**LRB-2023-09**  
**22/01707/FLL – Erection of 4 dwellinghouses and 3**  
**garages, land 50 metres south east of Craighton Gardens,**  
**Cleish**

**LRB-2023-09****22/01707/FLL – Erection of 4 dwellinghouses and 3  
garages, land 50 metres south east of Craighton Gardens,  
Cleish**

**Town and Country Planning(Scotland) Act 1997 as amended**  
**Planning Application Ref: 22/01707/FLL**  
**Appellant: Mr RS Black**  
**Date: January 2023**

Figure 2: Footpaths out to B9097

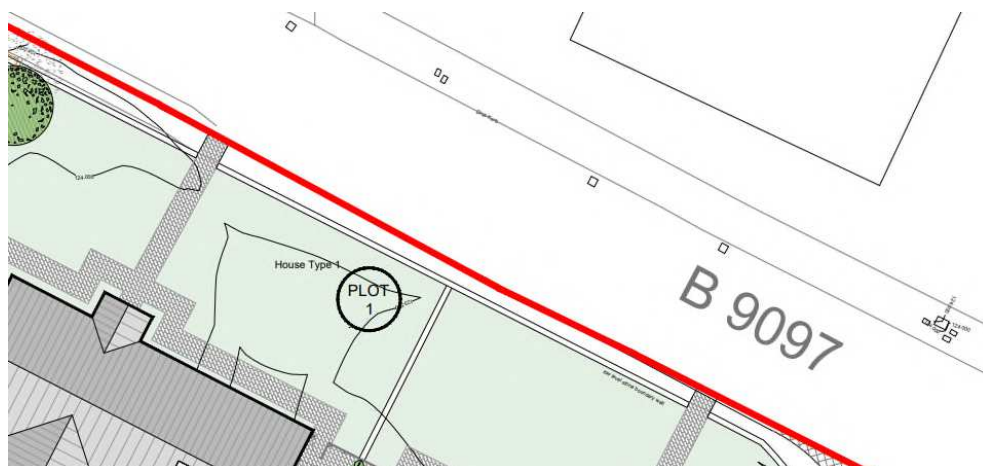
The plans also show paths out to the public road network, it is unclear if these will be linking to a footway along the B9097, as shown in Figure 2. Without links to a footway, the Roads Maintenance Partnership have concerns about these being provided directly onto the B9097. **Clarity to be provided.**
